Access Compliance Report

Public Rights-of-Way

Intersection ID: N/A	Main Street: NORTHLAKE CENTRE PY	Cross Street: N/A	Location: NW
ADA ID: 60C064FA1FC4	Ramp Type: PerpDiag	Initial Pass/Fail: Pass	Overall Compliance: No
		Severity Score: 0

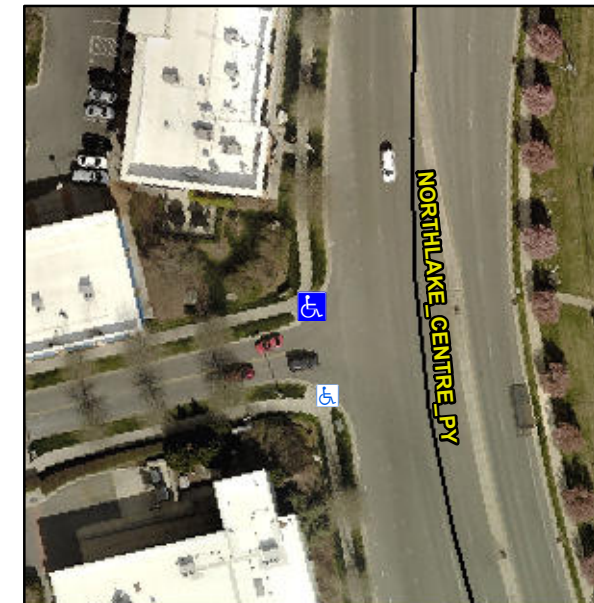
Not Found, R304.2.1, R304.2.2-Perp, R304.3.2-Para, R305.2

Remove & Replace Curb Ramp With Two New Directional Ramps or Equivalent.
